ADDENDUM

JLG 24146.01-5 Dunn County Public Safety Center

Issued: November 13, 2025

ADDENDUM #: 03

DATE: 10/21/25
PHASE: CONSTRUCTION DOCUMENTS
PROJECT: 24146.01
SHEET: **S102**
FIRST FLOOR FRAMING PLAN

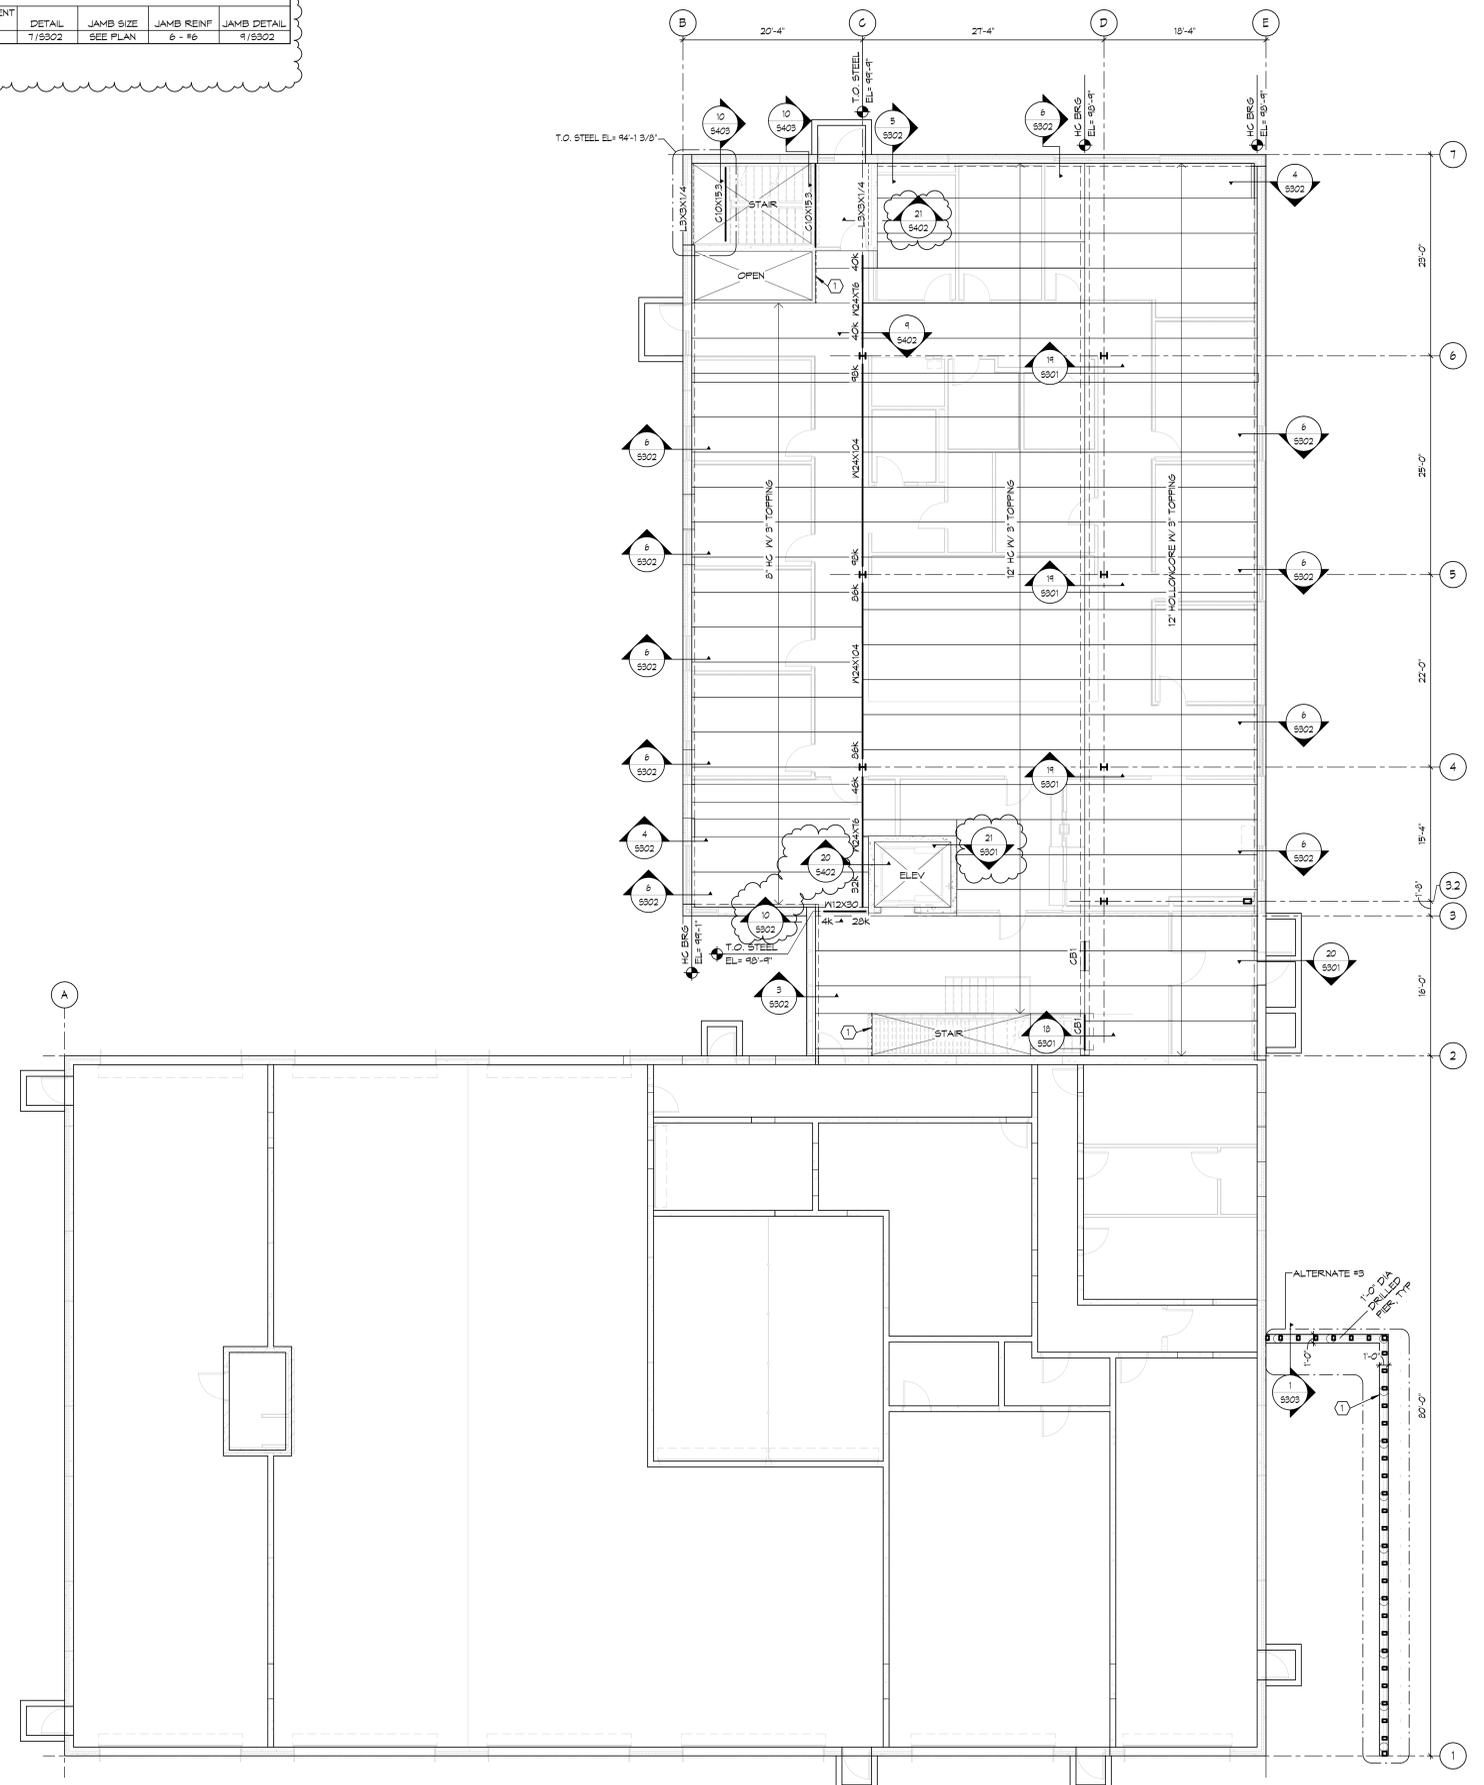
2. S102 – FIRST FLOOR FRAMING PLAN
 - o First Floor Framing Plan: Added details 10/S302, 20/S402, & 21/S402.
 - o Concrete Beam Schedule Added.
3. S103 – SECOND FLOOR FRAMING PLAN

7 REINF DEVELOPMENT LENGTH DETAIL
S302 1/2" = 1'-0"

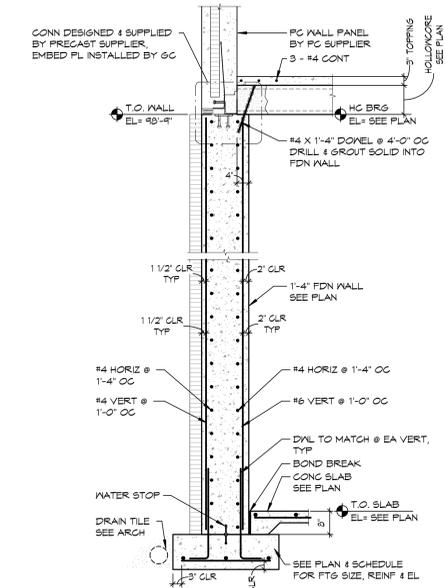
- o Detail 7/S302: Reinforcement Development Length Detail added.
 - o Detail 8/S302: Concrete Beam Detail added.
 - o Detail 9/S302: Concrete Jamb Detail added.

Power Plan - Basement
1/8" = 1'-0"

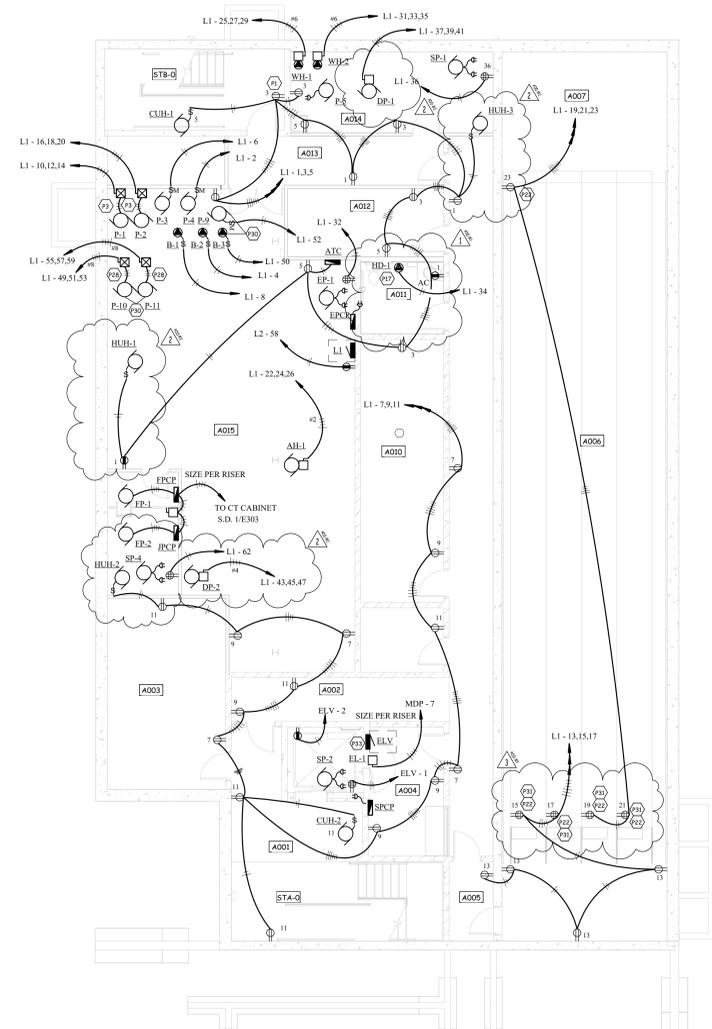
1. E300 – BASEMENT POWER PLAN
 - o Drawing 1/E300: Updated receptacles for the firing range to double duplex.
2. E301 – LEVEL 1 POWER PLAN
 - o Drawing 1/E301: Added keynotes to devices in precast wall.
3. E400 – BASEMENT SYSTEMS PLAN
 - o Drawing 1/E400: Added fire alarm interface and keynote of smoke control system.
4. E401 – LEVEL 1 SYSTEMS PLAN
 - o Drawing 1/E401: Added fire alarm devices for smoke control system. Added select locations for fire alarm pull stations. Added keynotes to devices in precast wall.
5. E402 – LEVEL 2 SYSTEMS PLAN
 - o Drawing 1/E402: Added fire alarm devices for smoke control system.

1
E401
Systems Plan - Level 1
1/8" = 1'-0"

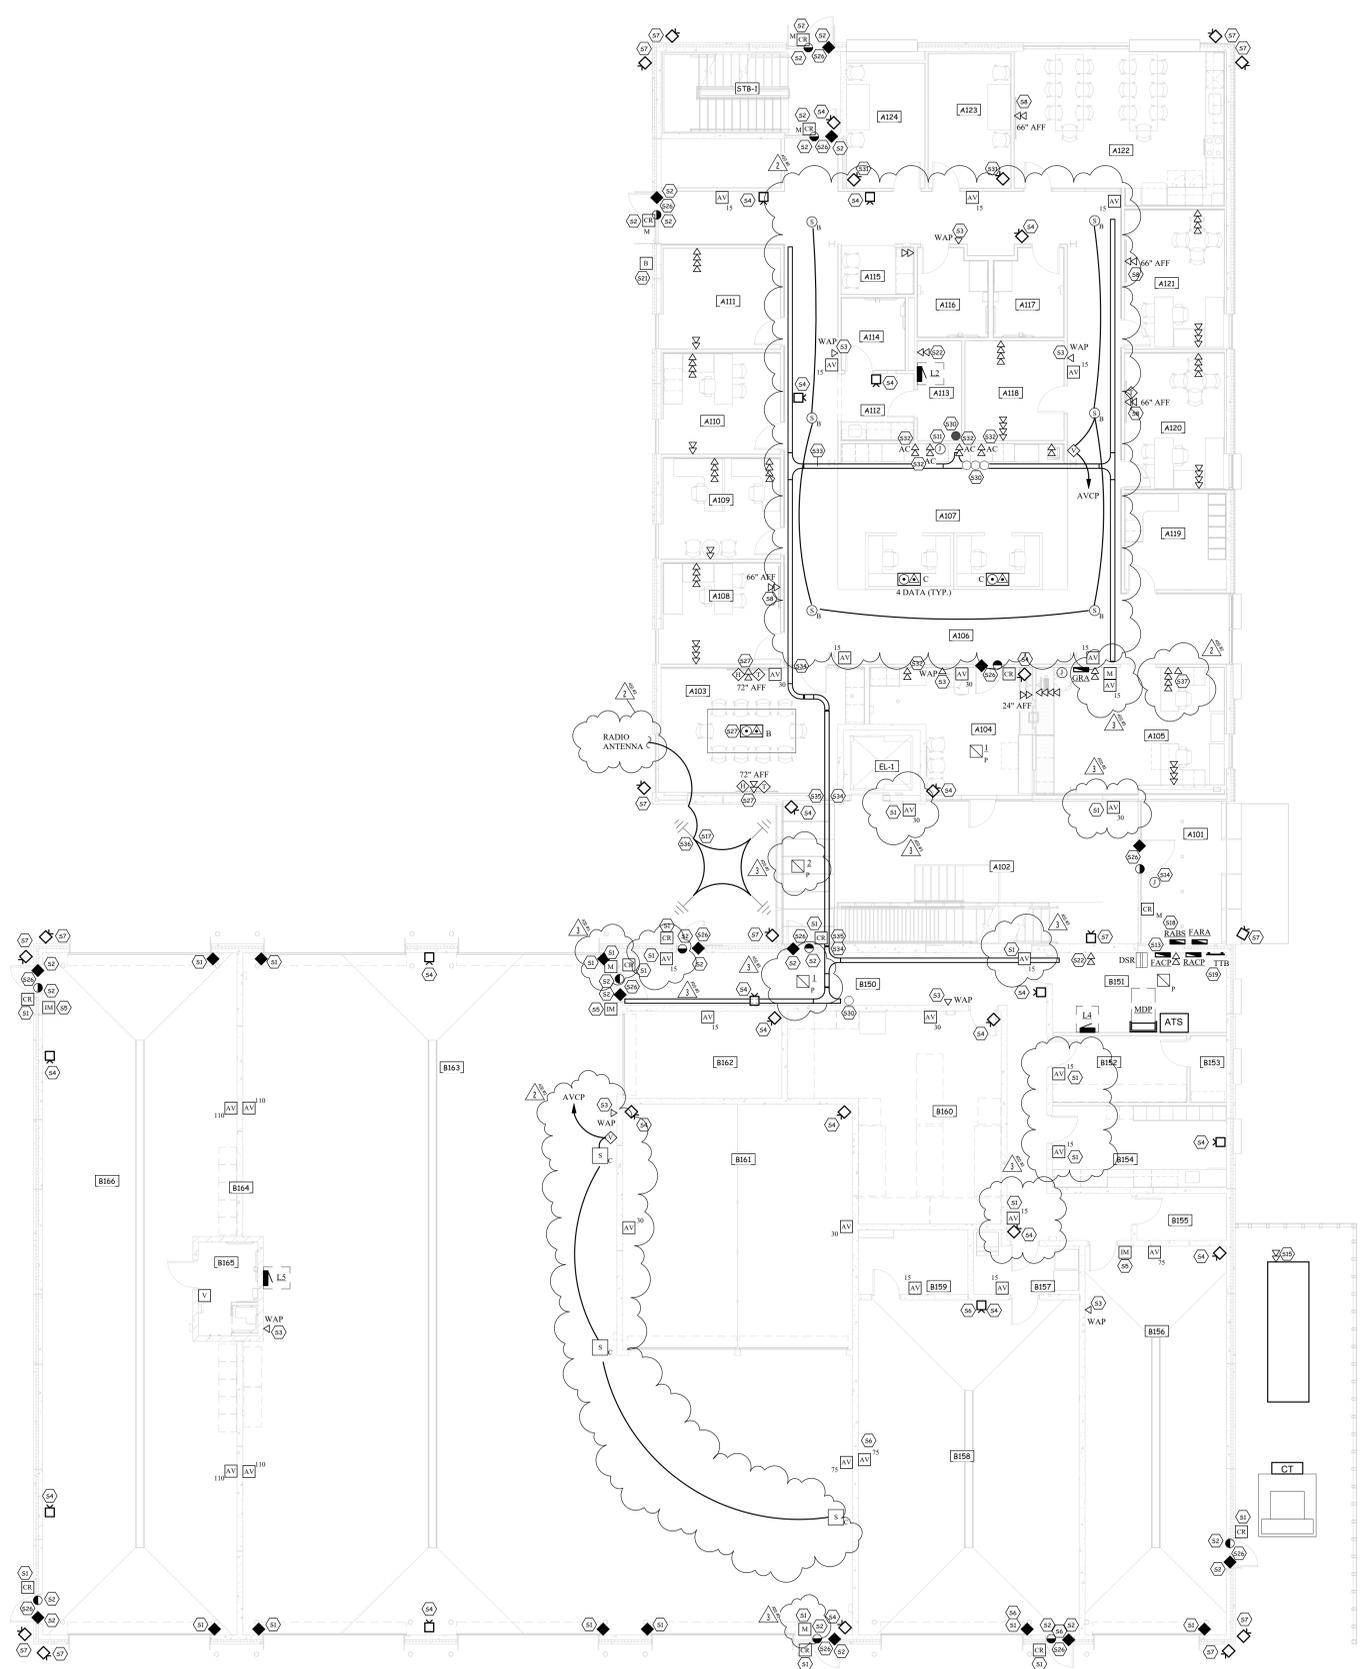
18	Public Safety Center		10/28/25	11/07/25	JE Dunn DFH QA/QC	Opening A101B is missing from the system plans (E401). Please review and add this opening to the system plans.	Door to be added to systems plan. To be address via addendum.
19	Public Safety Center		10/28/25	11/07/25	JE Dunn DFH QA/QC	Opening STB-1A / Hardware Set 38.2 – The hardware schedule has specified electrified hardware that would require a card reader on the push and pull side of the door but the system plans (E401) show that a card reader is only required on the pull side of the door. Please confirm if a card reader is required on both sides of the door or just one side. If the card reader is required on one side, please confirm what the new hardware set assignment should be.	This should be hardware group 38.0.
20	Courthouse		10/28/25	11/07/25	JE Dunn DFH QA/QC	Opening E110B is shown on the system plans (E401) to receive a card reader, but this opening is not listed on the door schedule. Please add opening to door schedule and confirm what hardware set this opening should be assigned to.	Duplicate item to #9. Door added to door schedule and will be issued via addendum. Hardware group E18.0.
